REMARKS

MARKED-UP CLAIMS PURSUANT TO 37 CFR § 1.121

APPLN. NO. 09/852,445

ATTY. DKT.: TOPP-P2-US

FIG. 7

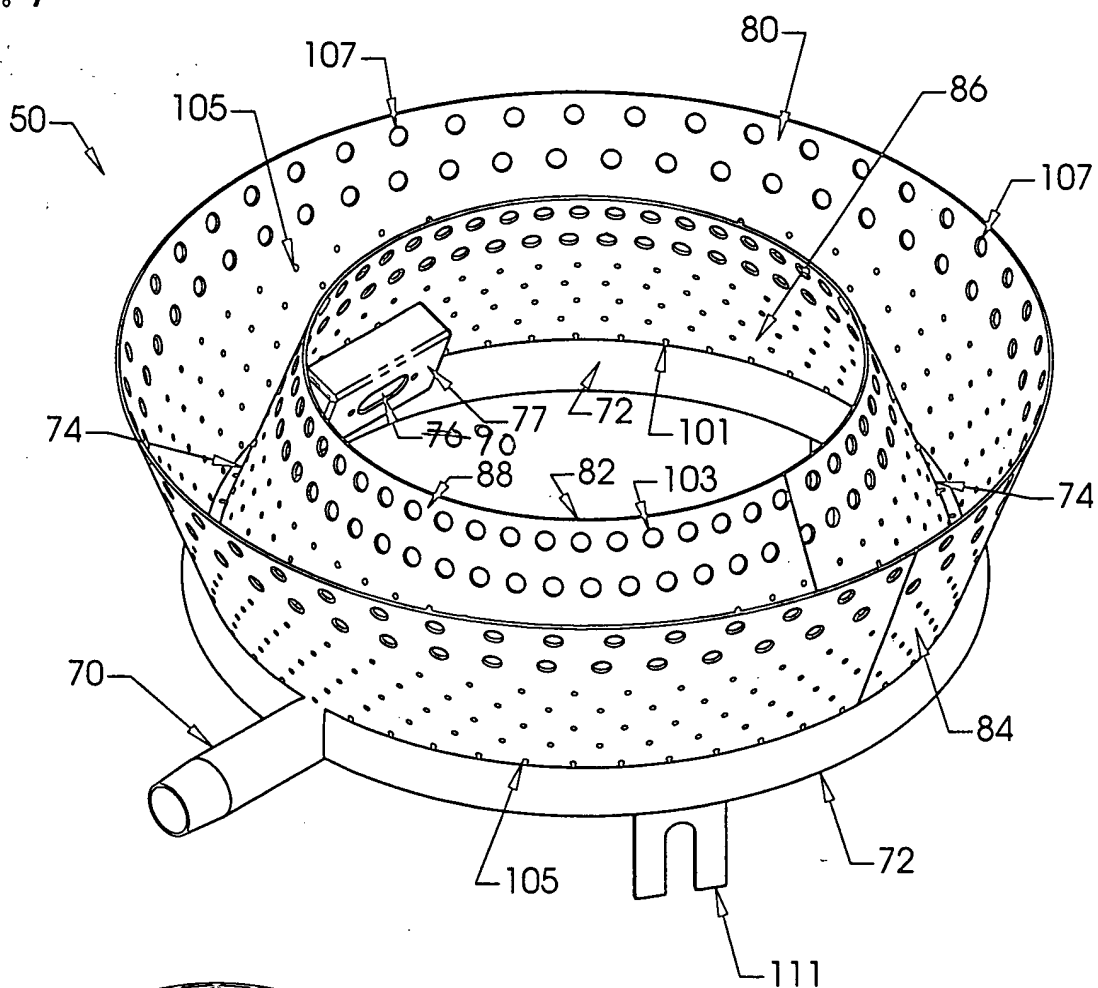
The Examiner noted that reference numerals 76 and 90 were both used to identify the ignitor. Applicant has deleted reference numeral 76 on Figure 7 and renumbered it 90. Applicant submits herewith a copy of Figure 7, with the change in reference numeral marked in red, and requests the Examiner's authorization to permanently amend Figure 7 accordingly.

Gas enters the combustion system 50 through tube 70 and eventually is relatively evenly distributed throughout ring-shaped burner tube 72. As gas leaves via gas exit holes 74 it is ignited by ignitor 90 [76]. After the gas is ignited, the control circuit ensures that a stream of gas exits gas holes 74, thereby ensuring that a flame is continuously lit at the combustion system 50.
